REMARKS

Please amend this application as follows:

In the Drawings:

Fig. 1

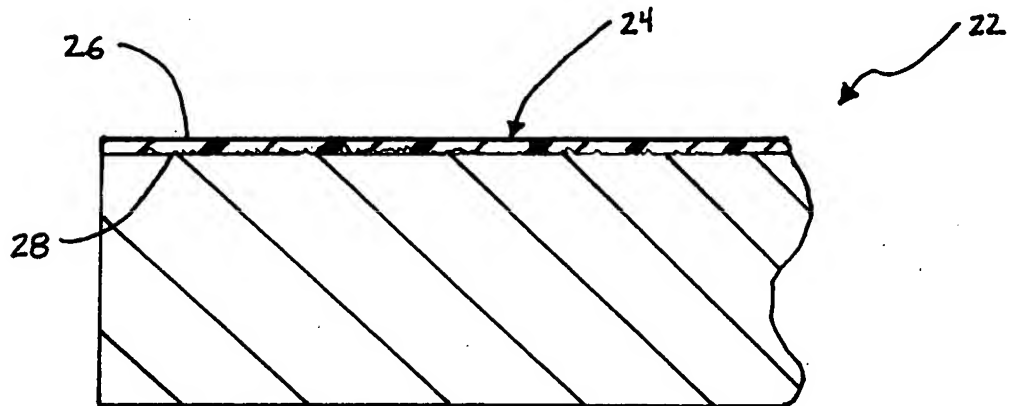
Added Element
Number 100 and added
a workpiece

Fig. 3

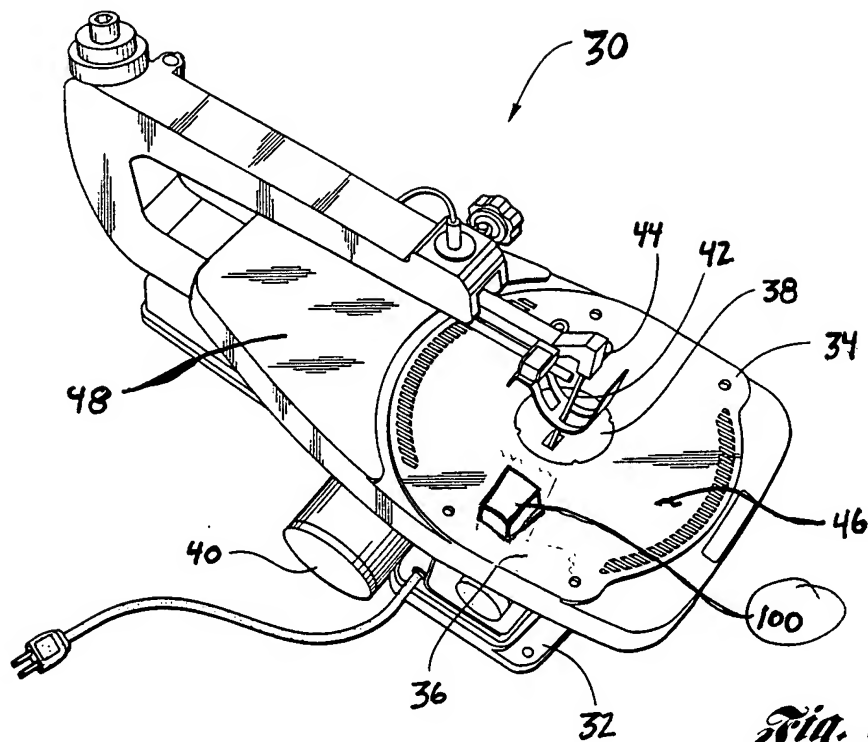
Added element
100 and added
a workpiece

Fig. 4

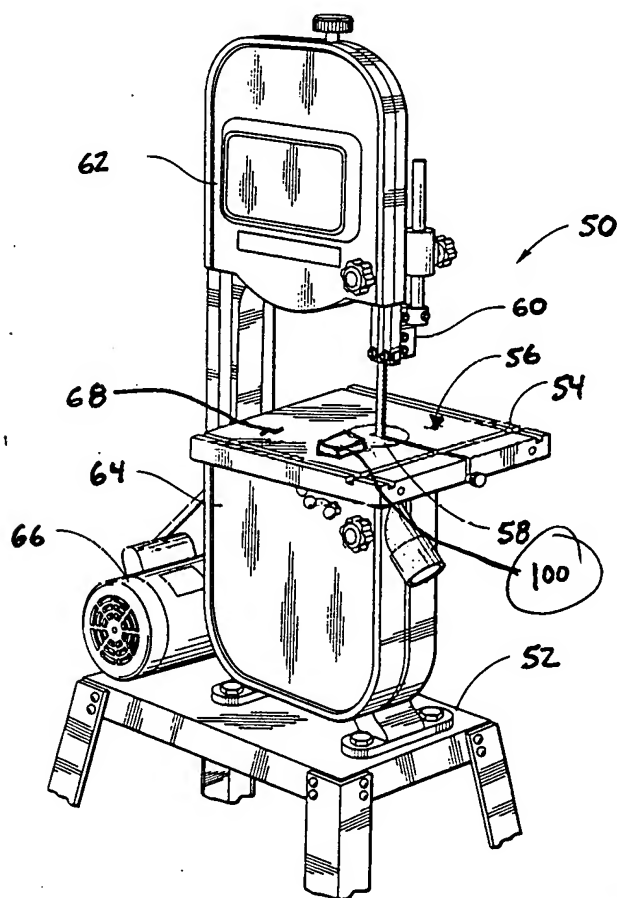
Added element
100 and added a
workpiece
